Report for the Grenfell Tower Inquiry

The application for Building Regulations approval (Part B Fire) in relation to the refurbishment of Grenfell Tower - extent of control, the Building Control process adopted, the referenced guidance and practices adopted

Beryl Menzies FCABE PPBEng CBuildE CABE MRICS

October 2019 (Amended April 2020)

2 Proposed Plan - Window Level 1:20

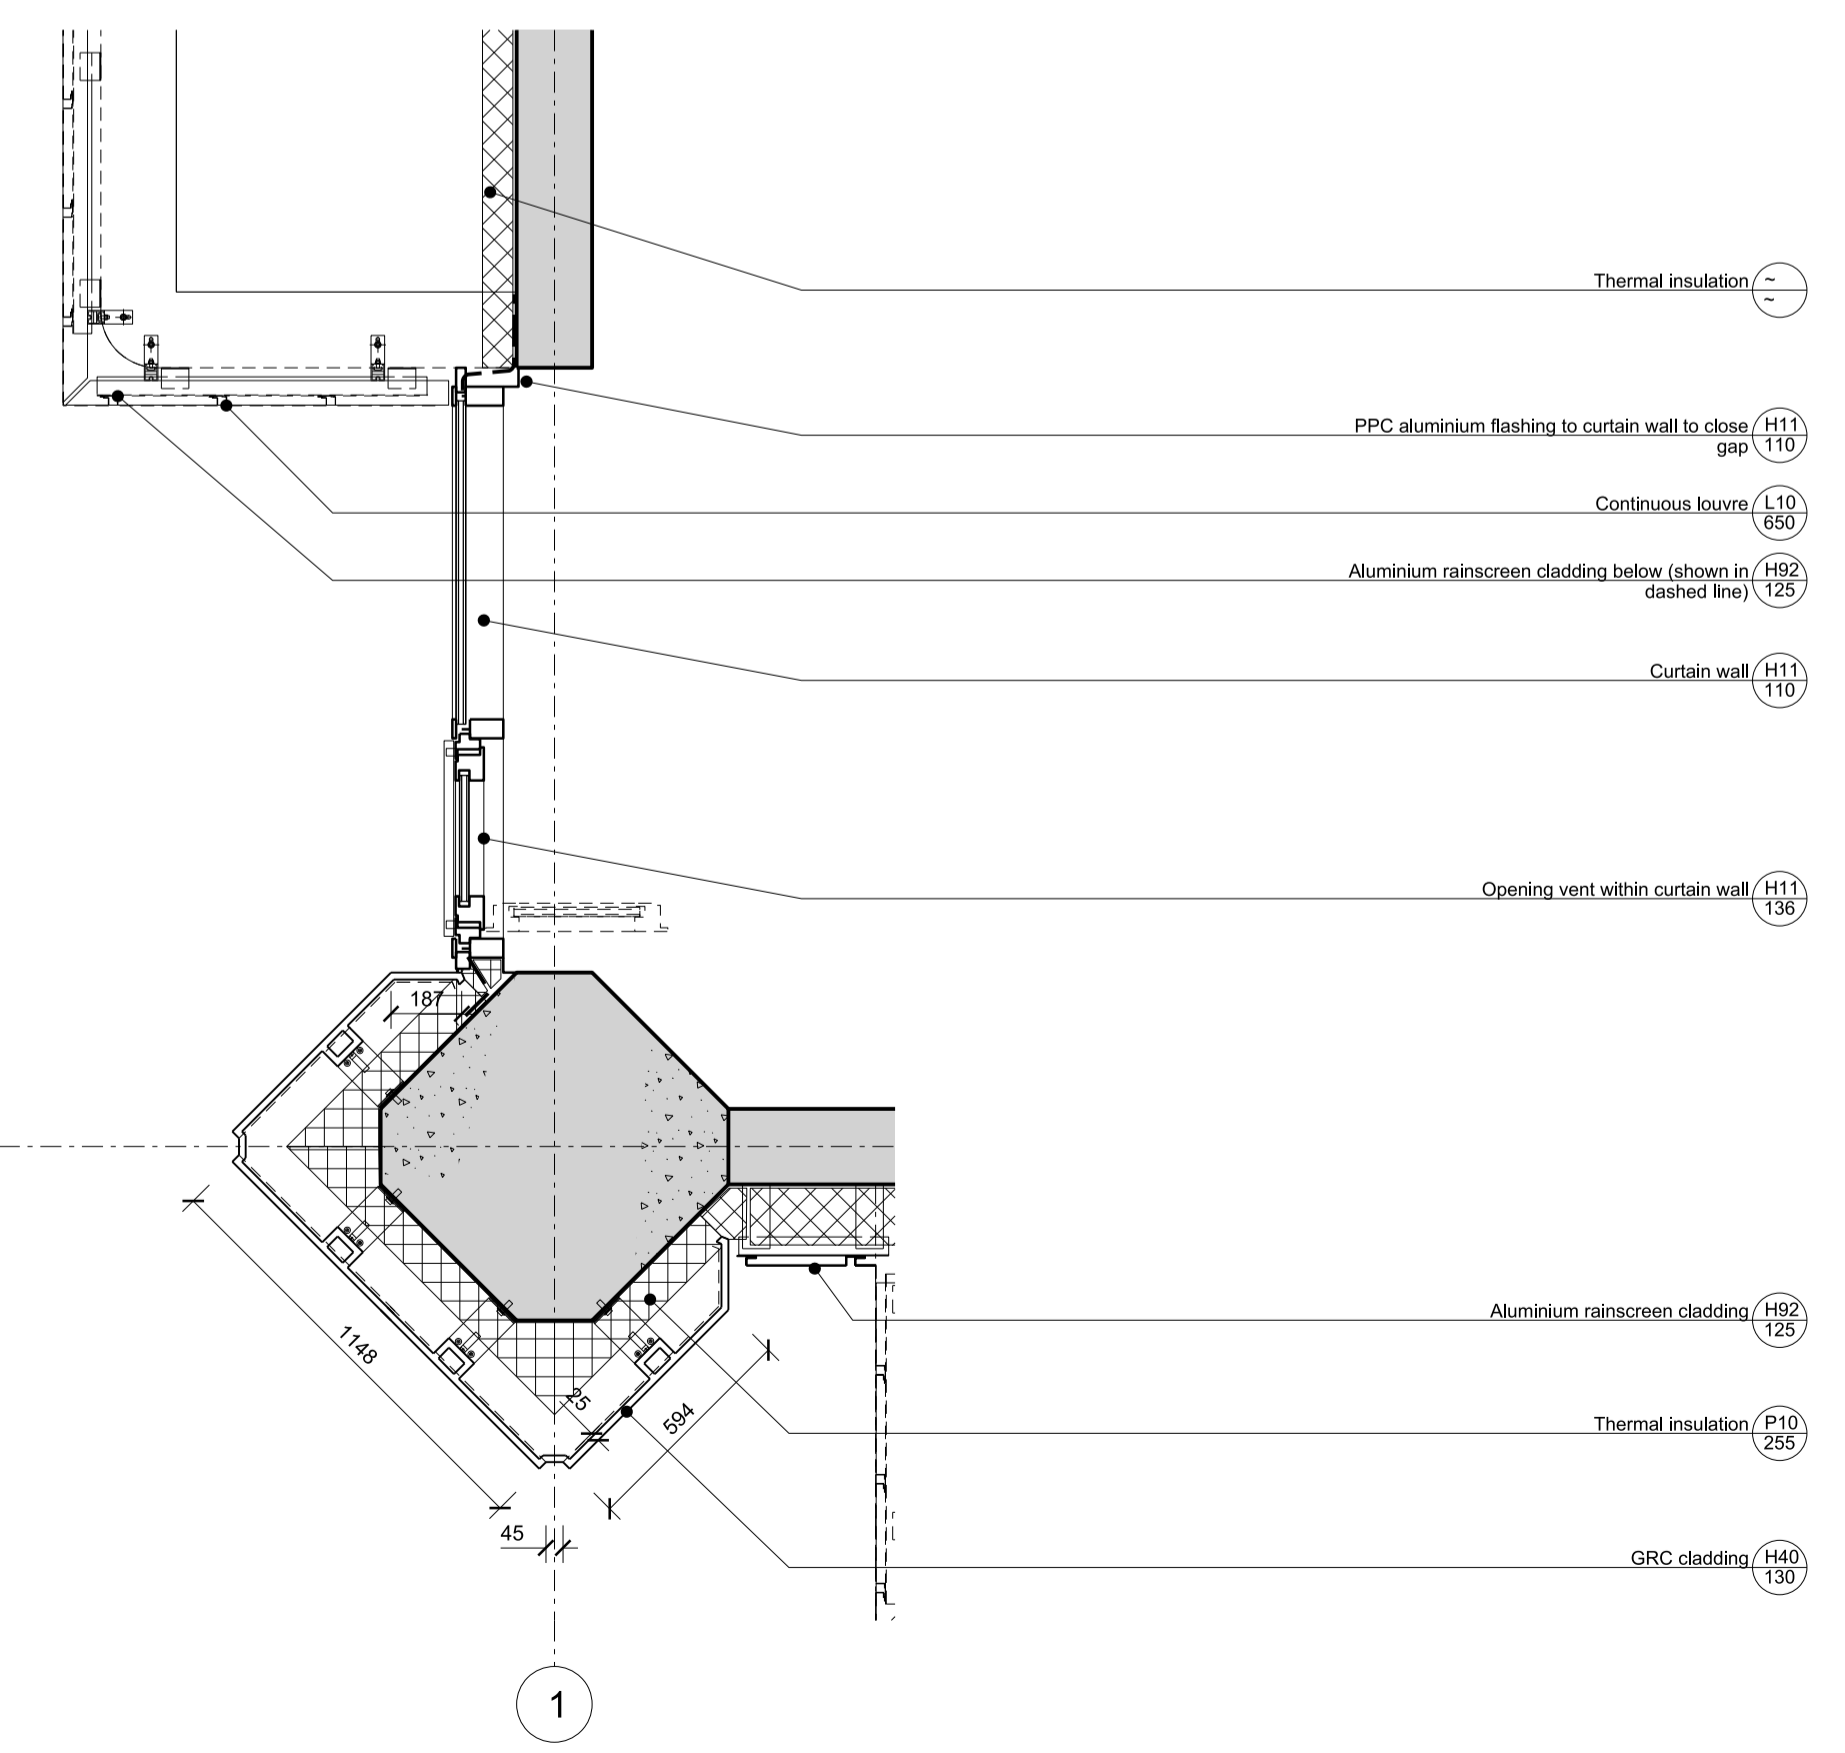
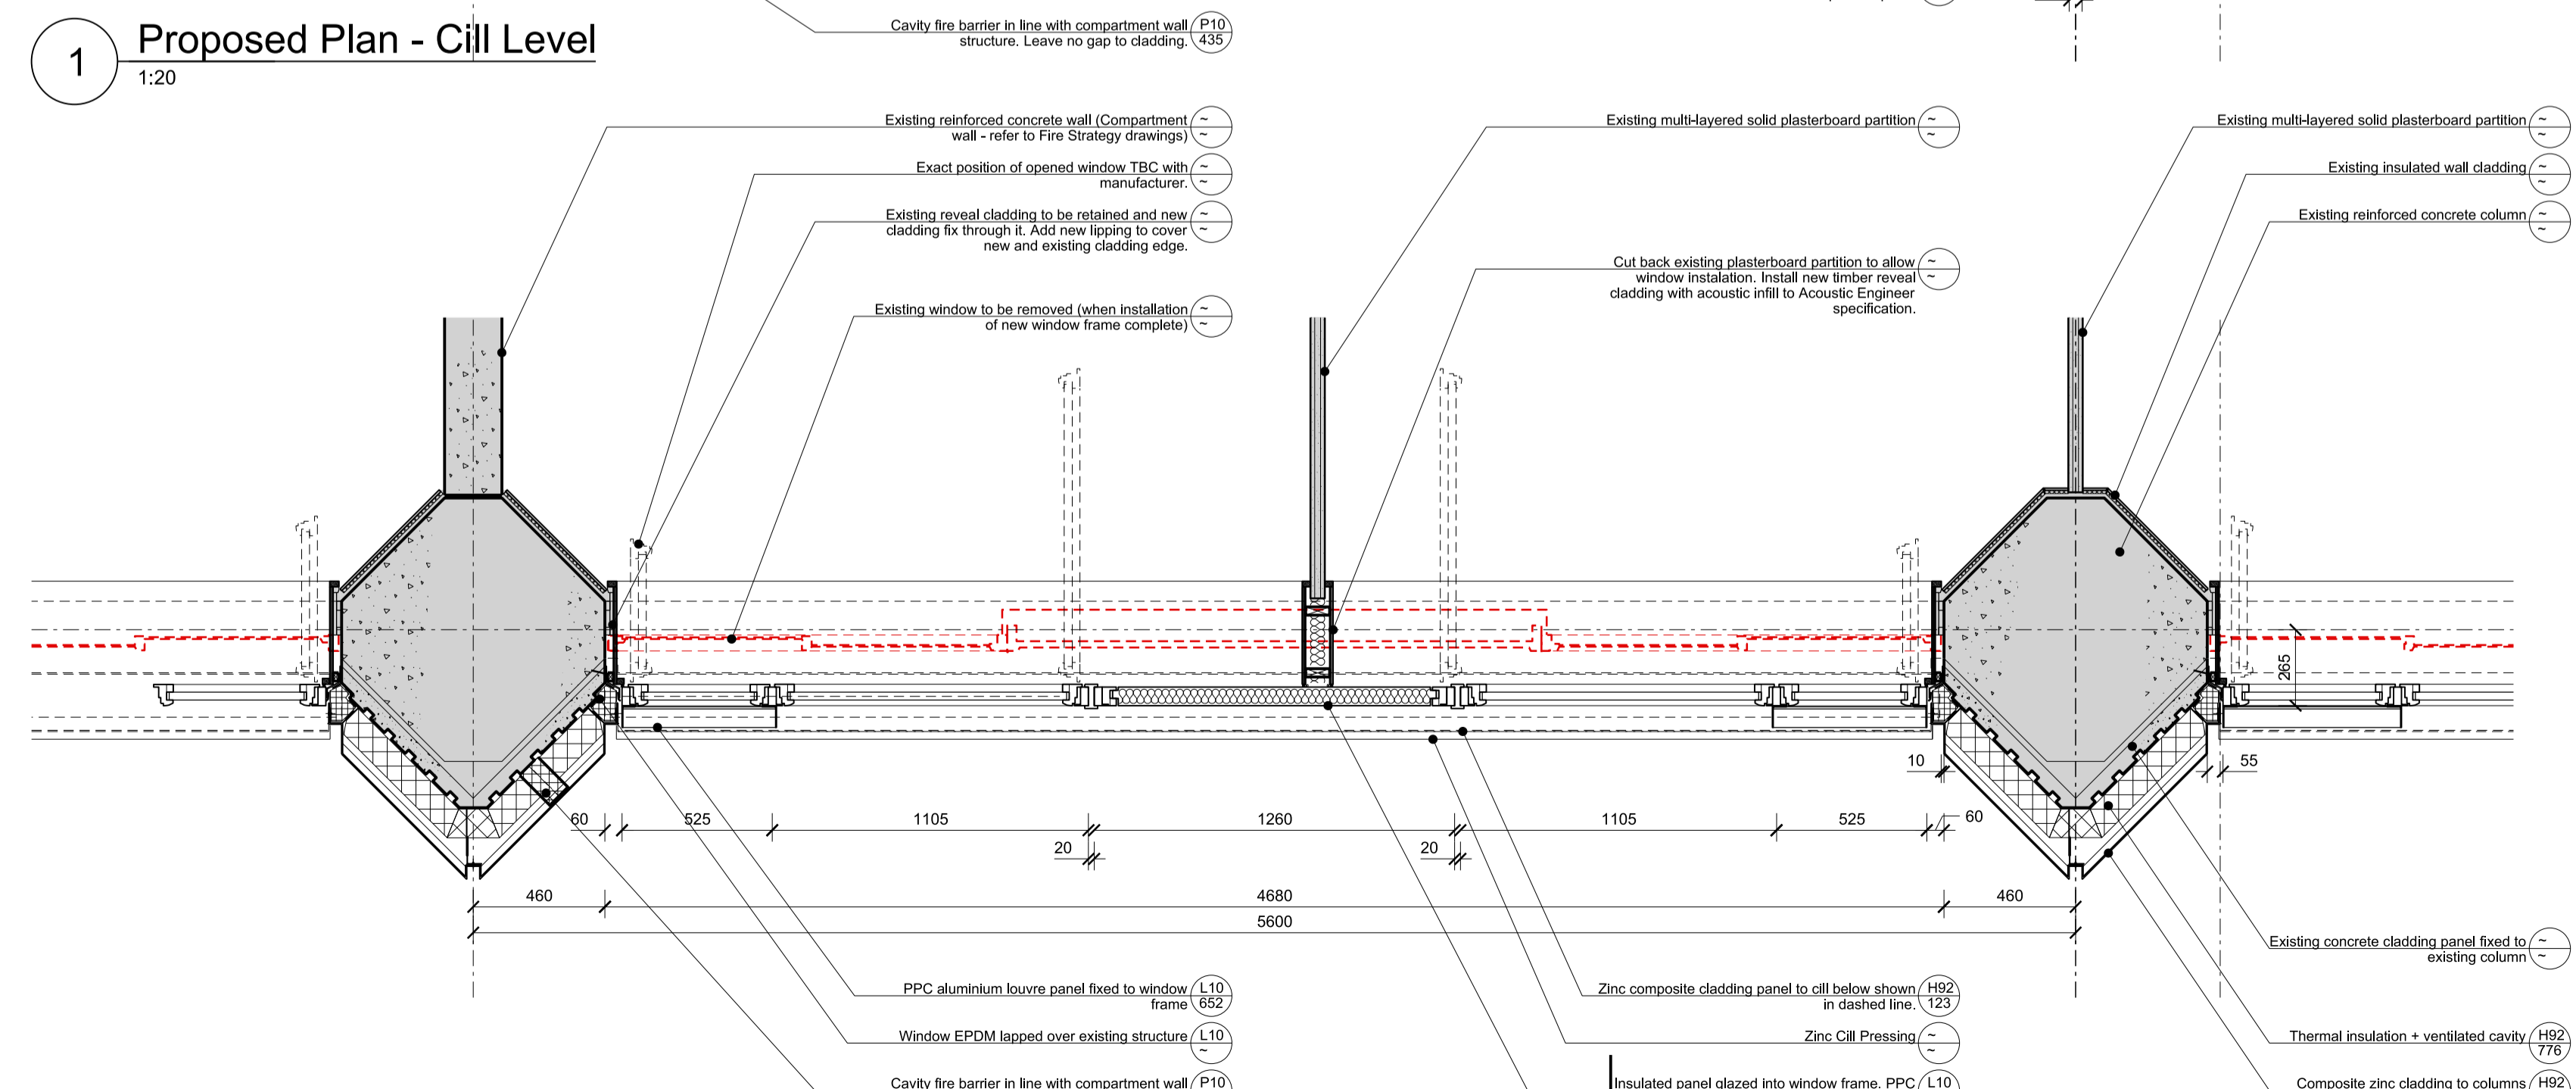
- 396) The details that were accepted by the BCB are shown in Studio E drawings 1279 (06) 110 rev 00 {HAR00006598}, 120 rev 00, 121 rev 00 {HAR00006597} and Harley’s drawing C1059-325 rev C {HAR00006599} (covering email is {HAR00006596}). These are shown below. The Inquiry will note that the Studio E drawings did not include cavity barriers at the head, jamb or bottom of the windows. In the Studio E drawing 1279 (06) 120 00, there is a cavity barrier above the head of the window in line with the compartment floor. In principle, a BCB may have considered this cavity barrier to be effective as a window cavity barrier. However, I have seen no evidence that John Hoban adopted this approach. In the Harley drawings, the cavity barriers are only shown at compartment floor lines. There is therefore an inconsistency between the drawings. I have not seen any evidence that this inconsistency was queried.

398) Drawing 1279 (06) 110 Rev 00 indicates a “Cavity fire barrier in line with compartment floor structure. Leave max 25mm gap to cladding for ventilation and drainage.”(Red arrow) This is not a cavity barrier to the window opening. The Inquiry will note that there is no cavity barrier at the base of the window above (blue arrow) where the floor is not coincident. The drawing refers to composite zinc rainscreen to window spandrel panel and is dated 24 September 2013.

-
- 399) The Inquiry will note that in drawing 1279 (06) 110 00 {HAR00019412} "Proposed plan - window level" the "existing" window position abutted the solid concrete column and the new window location is outward and abuts the new cladding and combustible EDPM giving rise to a gap through which fire and smoke could spread. A cavity barrier was required in this location (but not shown on the drawing or I understand constructed on site).

1 Proposed Section through Main Entrance
1:20

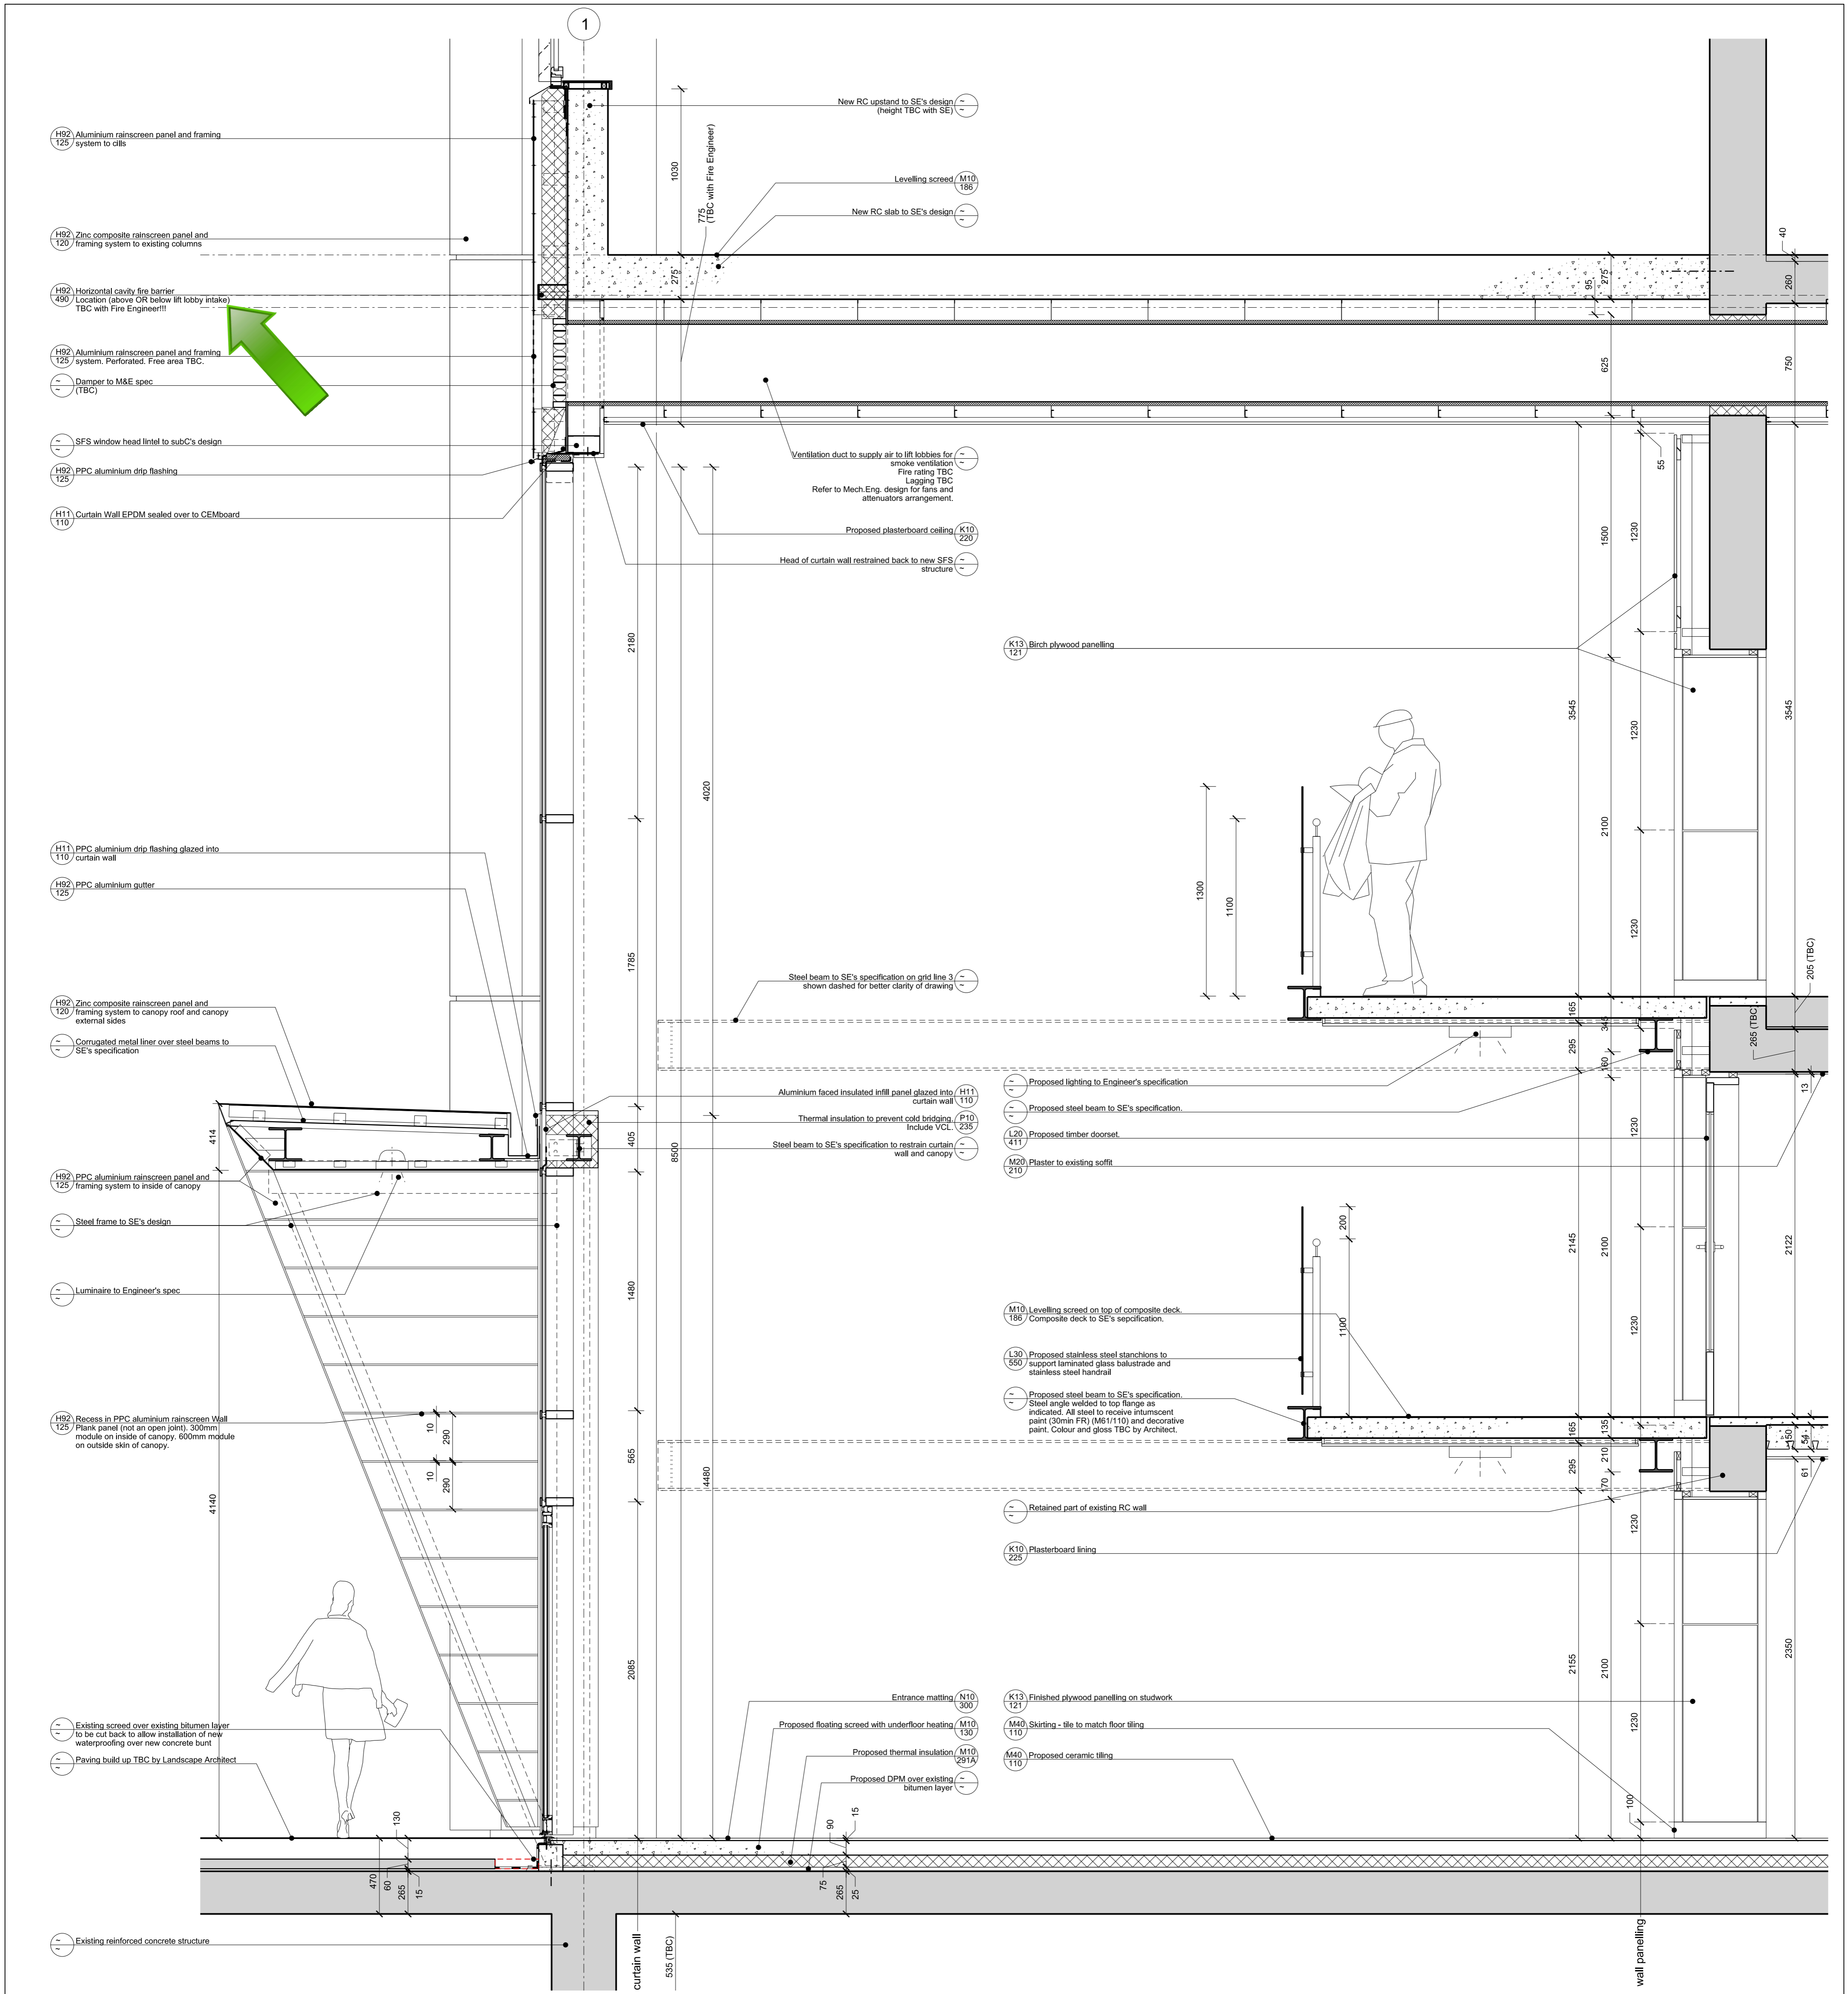
- 358) In his response regarding cavity barriers dated 1 April 2015 {HAR00006596} John Hoban drew attention to the need for the new steelwork supporting the new gallery floors shown on drawing 1279 (06) 121 Rev 00 (drawing shown below) should be protected to 120 minutes fire resistance. There was no reference to the proposal to reduce the fire resistance to 30FR within the Exova fire strategy. It is therefore unclear whether the proposal in the Exova strategy formed part of the refurbishment works.

- 425) Insulation (un-named) behind the insulated panels. In the email chain {HAR00006596}, Mr Hoban references drawings 1279 (06) 120 rev 00, 121 Rev 00 and Harley's drawing C1059-325 rev C (shown below). These clearly indicate insulation behind the panels albeit the detail relates to the lower levels only.
